MODIFICATION SHEET

PHILIPS RADIOPLAYER

MODELS 117A, 117B

MODELS 117A, 117B

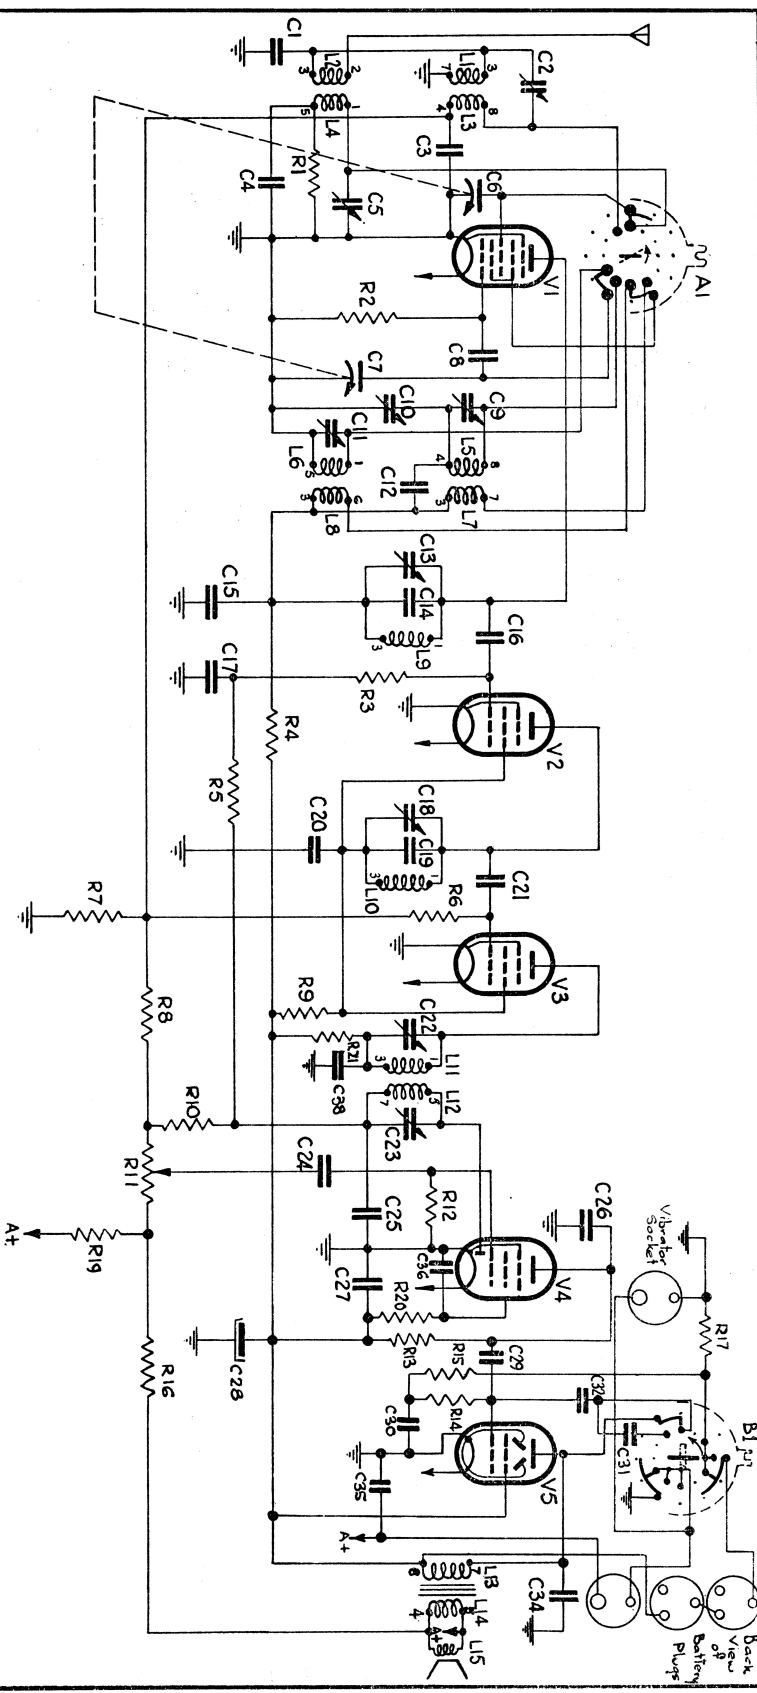
This receiver is identical with Model 117, except for the change of valve type 1Q5GT in place of type 3S4. There are also minor changes in the circuit diagram (deletion of R18, C33, and C37). Circuit diagram is published overleaf.

C26	565pF mica	R17	350 ohms $\frac{1}{2}$ W W/W
C33	deleted	R18	deleted
C37	deleted	R20	2 megohms 1W carbon
R13	250,000 ohms 1W carbon
